NL-13-001

SUBJECT: Proposed Changes to Indian Point 2 Technical Specifications Regarding Reactor
Vessel Heatup and Cooldown Curves and Low Temperature Over Pressure
Requirements
Indian Point Unit Number 2
Docket No. 50-247
License No. DPR-26

MARKUP OF TECHNICAL SPECIFICATION PAGES FOR PROPOSED CHANGES REGARDING REACTOR HEATUP AND COOLDOWN CURVES AND LTOP REQUIREMENTS

Figure 3.4.3-1:
Heatup Limitations for the Reactor Coolant System (RCS) and
Hydrostatic and Inservice Leak Testing Limitations for the RCS.

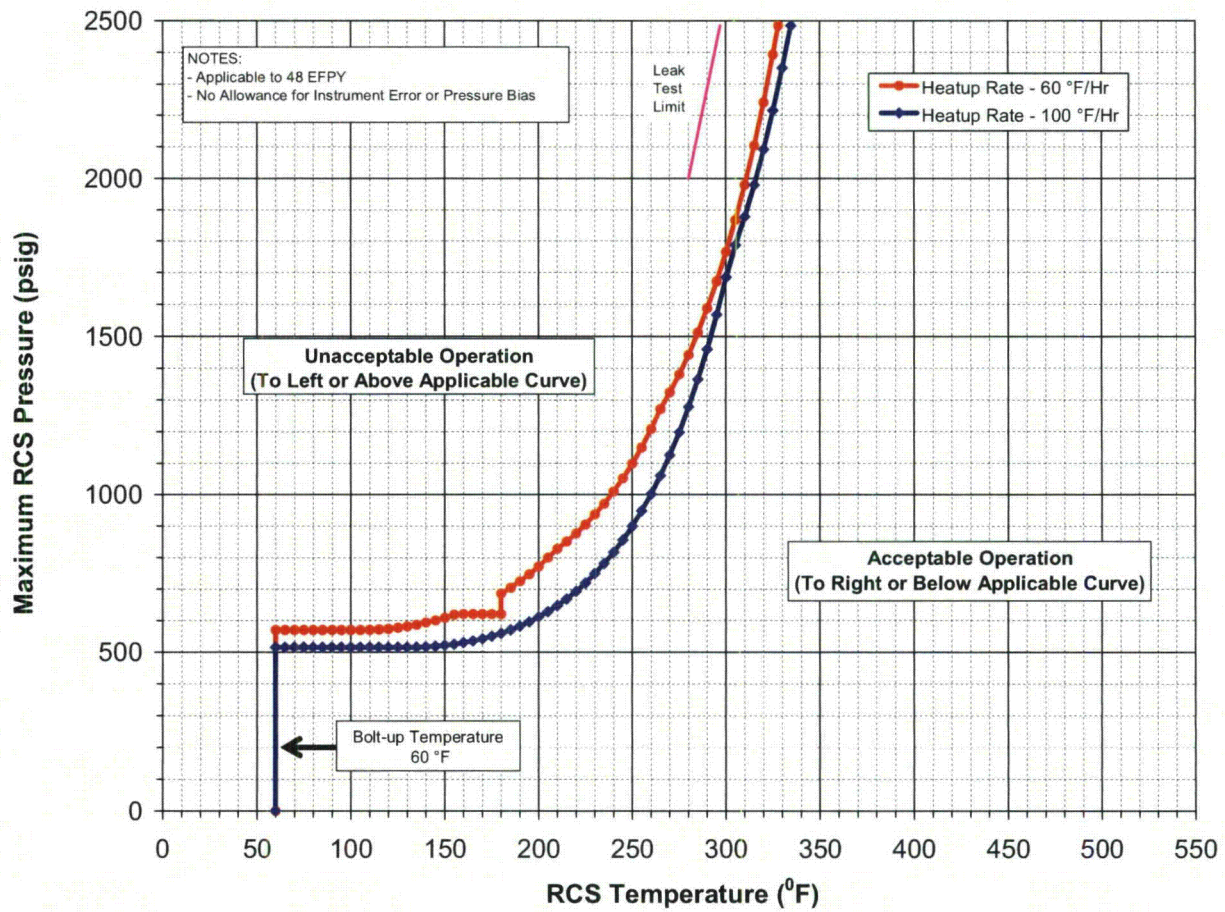
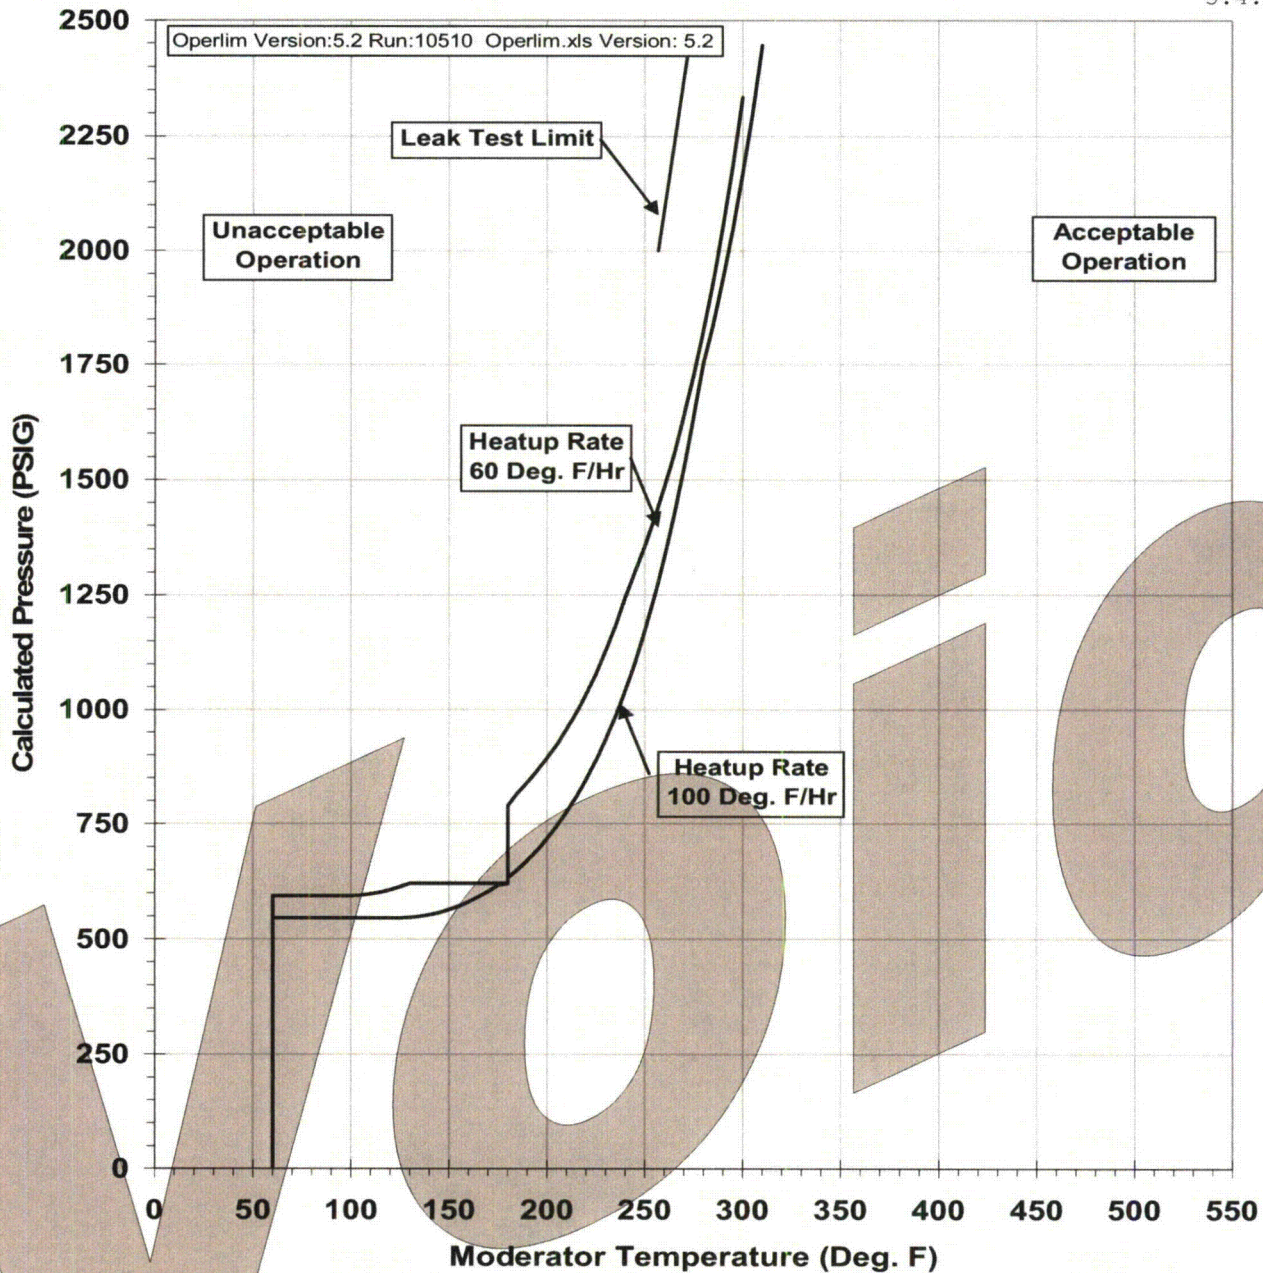
Replace the existing TS Figure 3.4.3-1 and Figure 3.4.3-2 with the proposed TS Figure 3.4.3-1 and Figure 3.4.3-2 as shown in attachment 2.

As expected, the revised curves are more restrictive than the existing ones, due to the effects of greater lifetime neutron fluence on the reactor vessel inner wall, and the associated increase in RT_{NDT} at the $\frac{1}{4}$ and $\frac{3}{4}$ locations. The methodologies used for the generation of the new curves are identical to those used for the existing curves. In accordance with ASME BPV Code Section XI, Appendix G, the LTOP Arming Temperature for the revised curves is increased from 280 degF to 288 degF, and this change is also reflected in TS Sections 3.4.6 (Note 2), 3.4.7 (Note 3), LCO 3.4.10 and TS 3.4.12.

Figure 3.4.12-1: Maximum PORV Opening Setpoint as a Function of Temperature

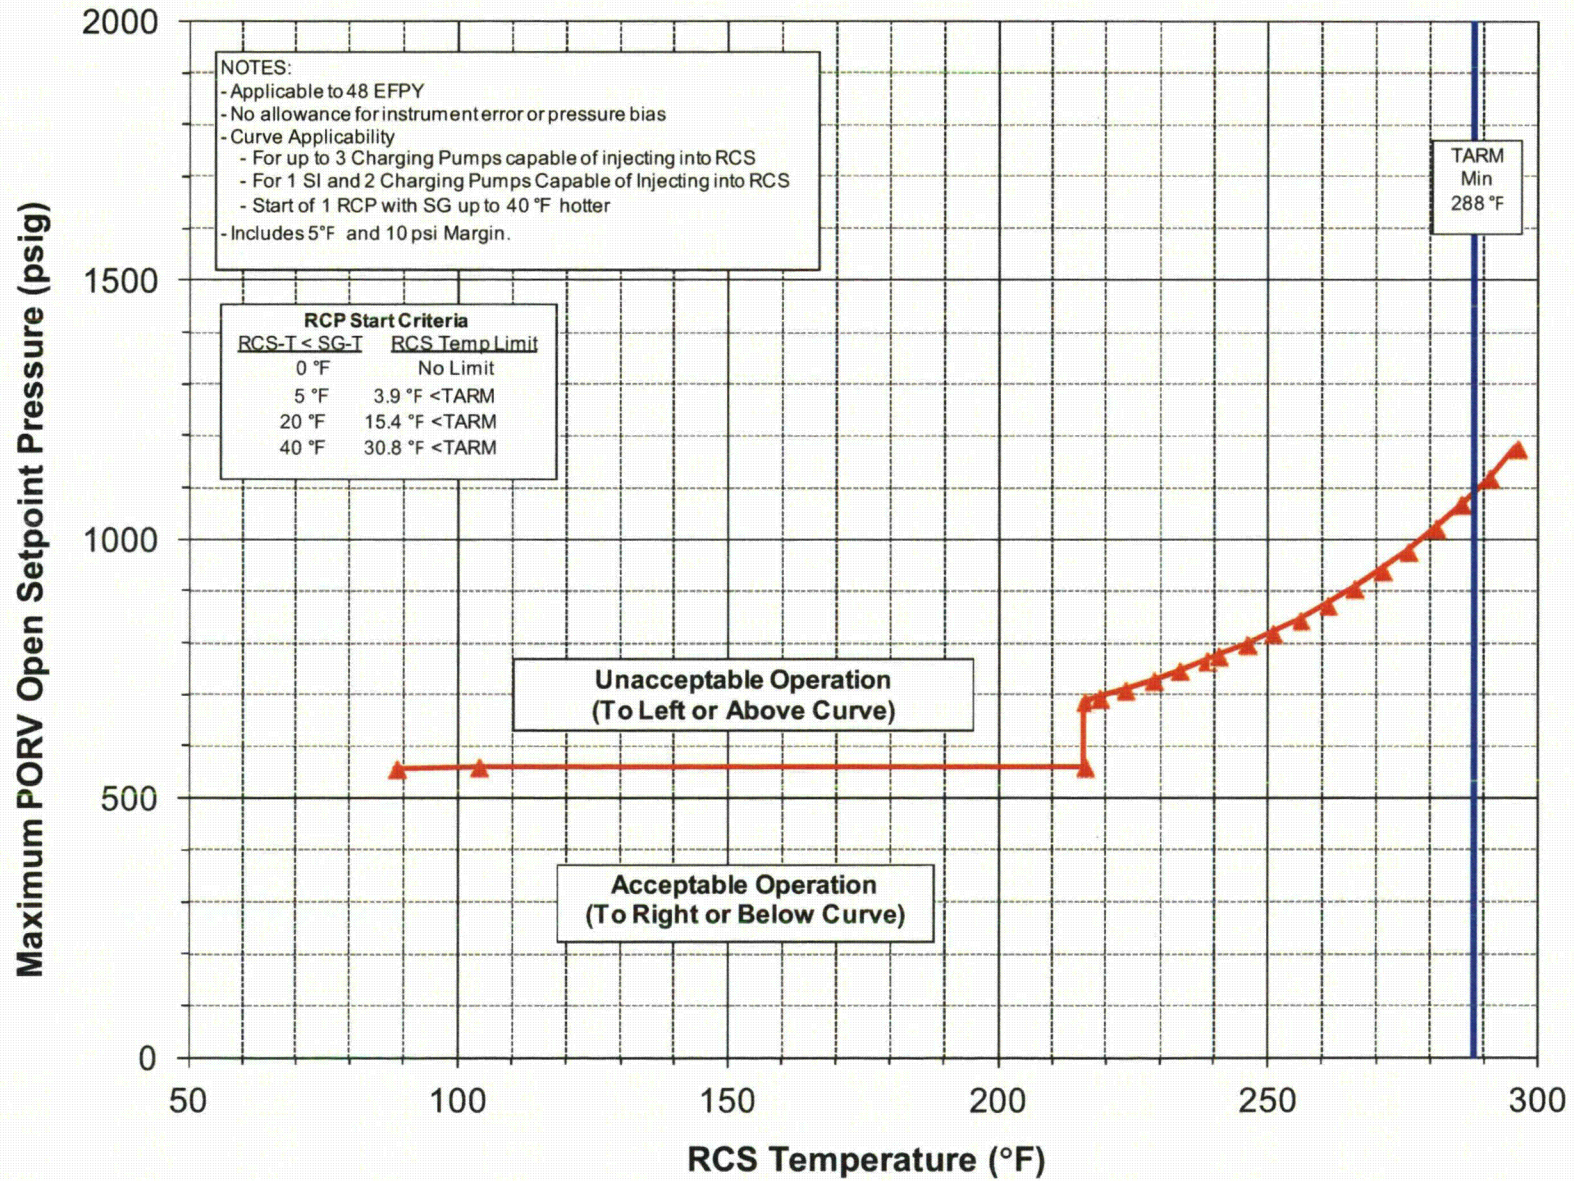
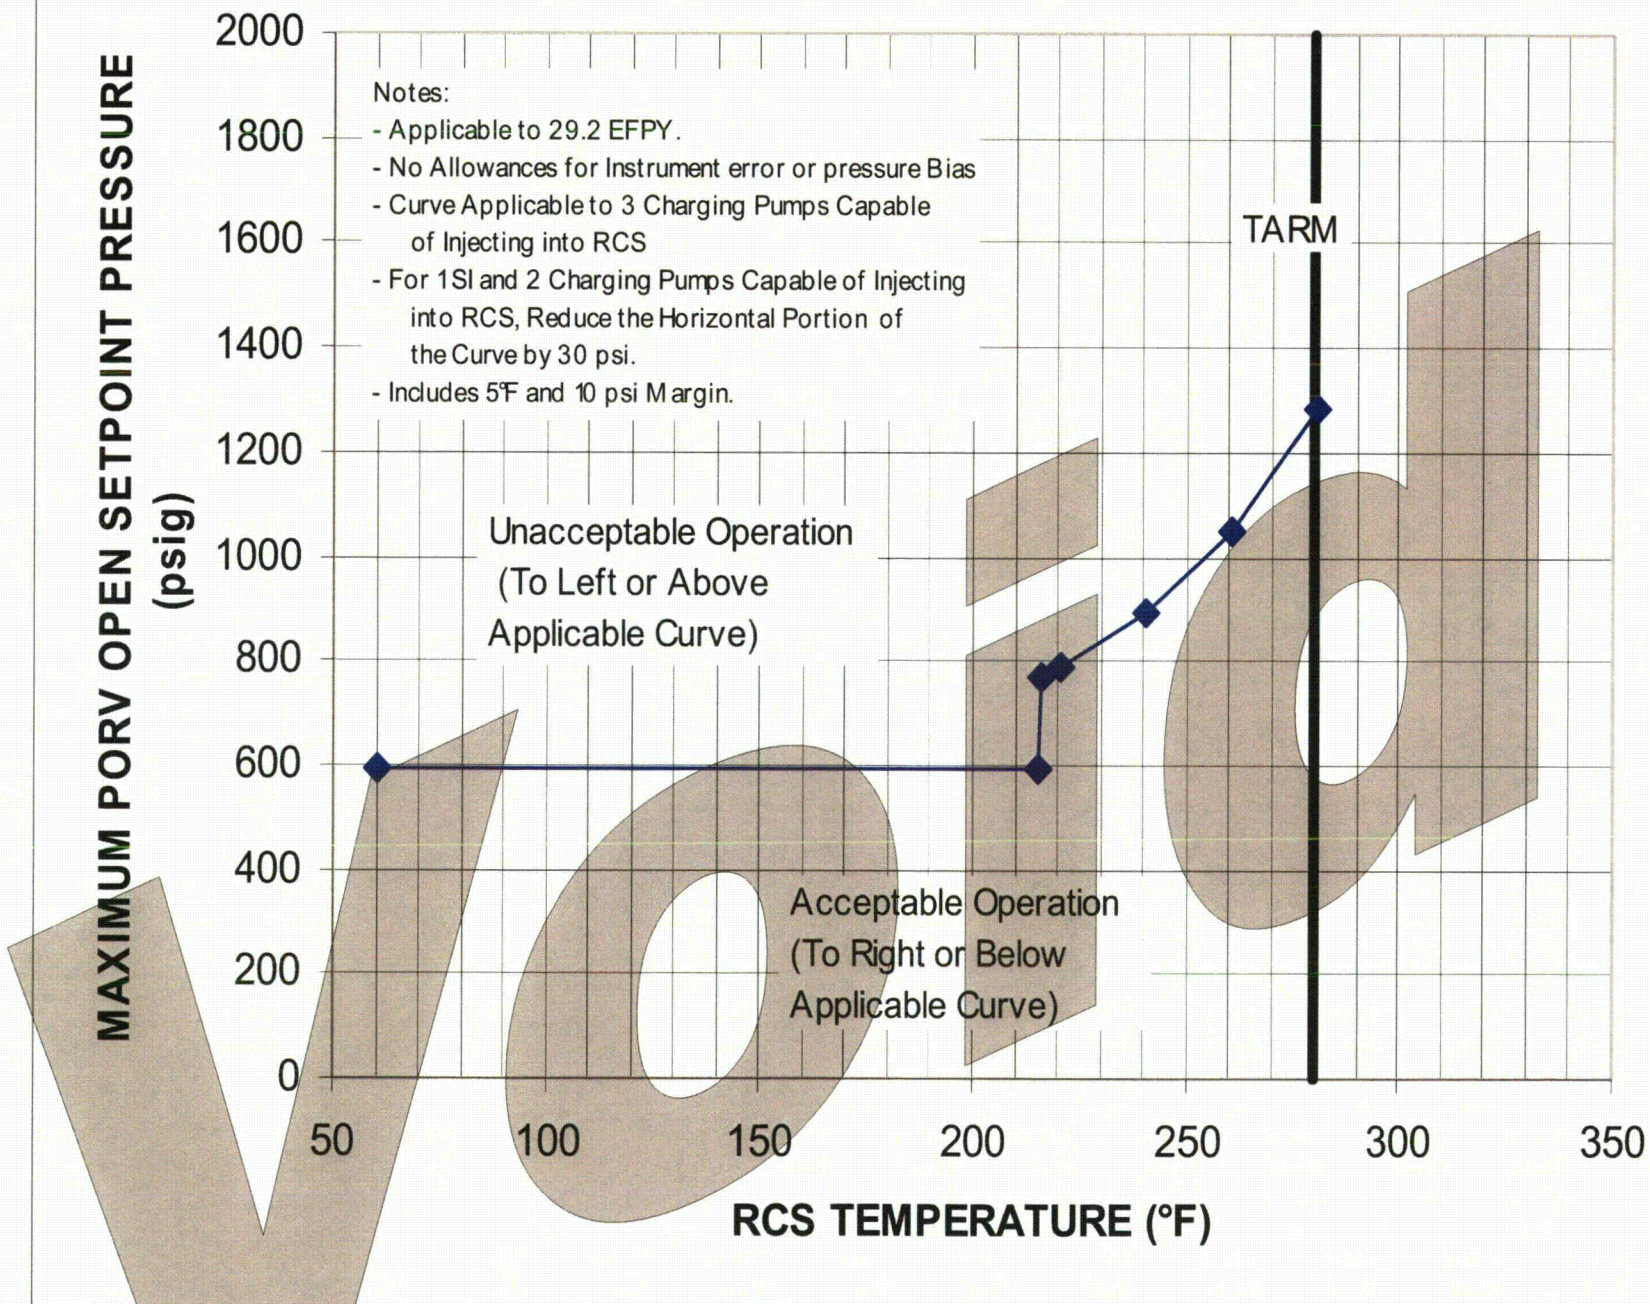
Replace the existing Figure 3.4.12-1 to Figure 3.4.12-6 with the proposed Figure 3.4.12-1 to Figure 3.4.12-6 as shown in Attachment 2.

The calculation for the LTOP curves uses a methodology identical to that of the existing curves, based on the source calculations for TS Amendment 262 (Reference 3). The LTOP curves in Reference 2 are based on the HU/CD curves established in Reference 1, and therefore the revised LTOP setpoints, and its family of associated curves, similarly reflect the increase in lifetime fluence for a service life of 48 EFY. The Maximum PORV Opening setpoint shown in Figure 3.4.12-1 is implemented as a variable setpoint for the LTOP instrumentation. The other curves in the LTOP family (as well as the HU and CD curves in Section 3.4.3) are procedurally implemented as Operations Procedure graphs and do not relate to any automatic protection systems.
